Product Change Notification / JAON-09HVKT693

CCB 6142 Initial Notice: Qualification of MPHL as an additional final test site for ATM90E36A-AU-R, ATM90E36A-AU-Y, SWF2L30B-AU-R, and SWF2L30B-AU-Y catalog part numbers (CPN) available in 48L TQFP (7x7x1.0 mm) package.

Pre and Post Change Summary

Tape and Reel – Cover Tape

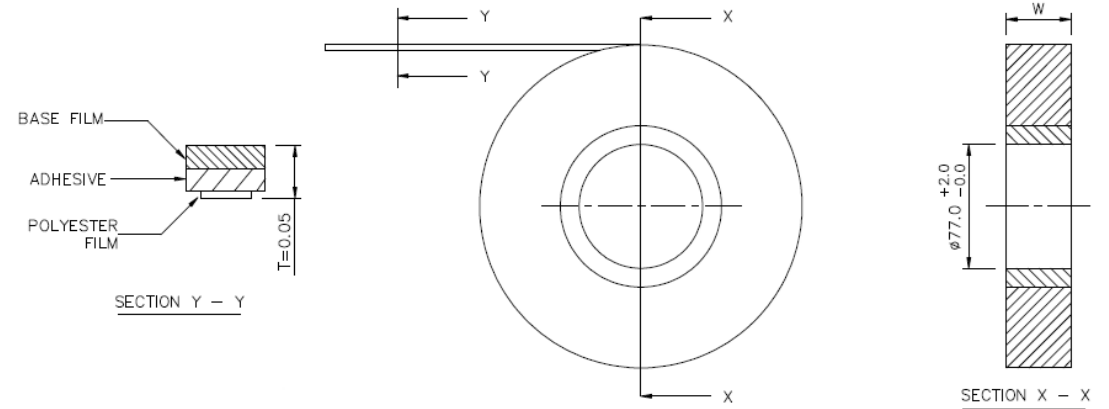
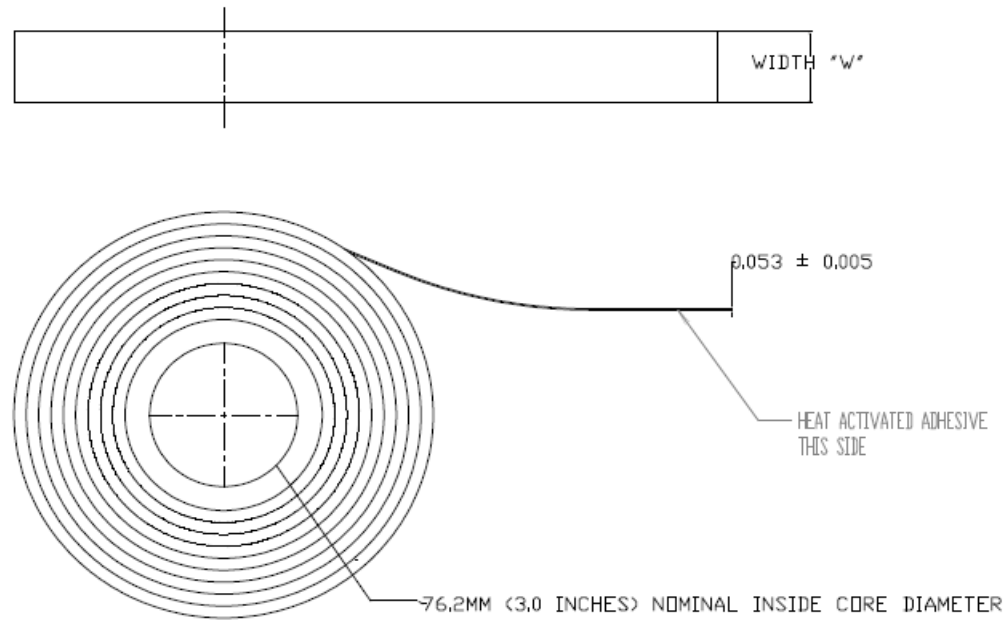
Plant	Carrier Width	Cover tape Width "W" (mm)	Thickness (mm)	Sealing Methodology
ASE9	16	13.3	0.053	Heat
MPHL	16	13.3	0.045 – 0.055	Pressure

TRAY

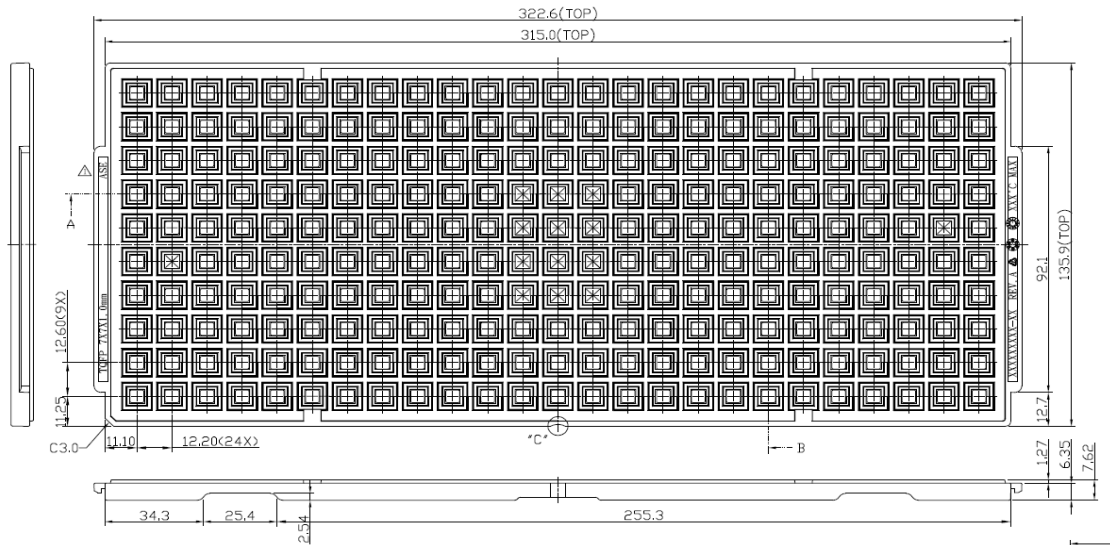
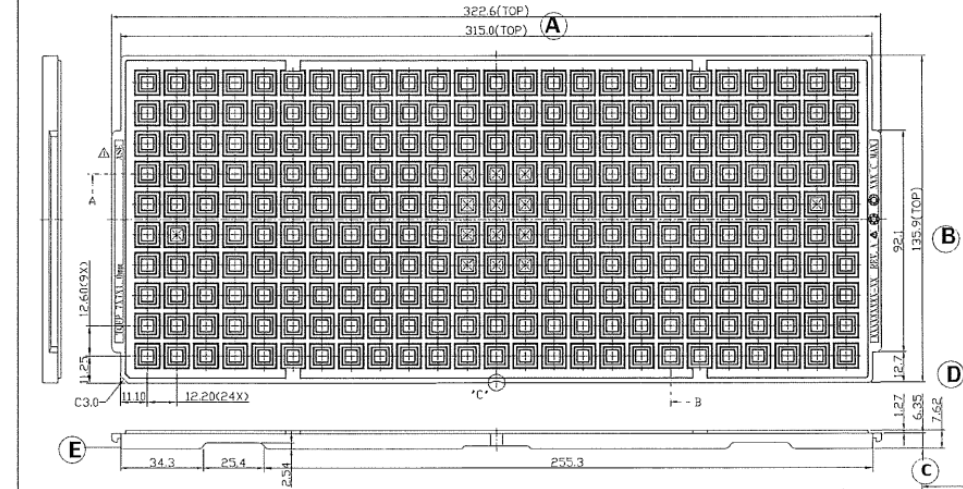
Plant	Length – max outer (mm)	Width – max outer (mm)	Thickness – max (mm)	Color	BQM
ASE9	315	135.9	7.62	BLACK	250
MPHL	315	135.9	7.62	BLACK	250
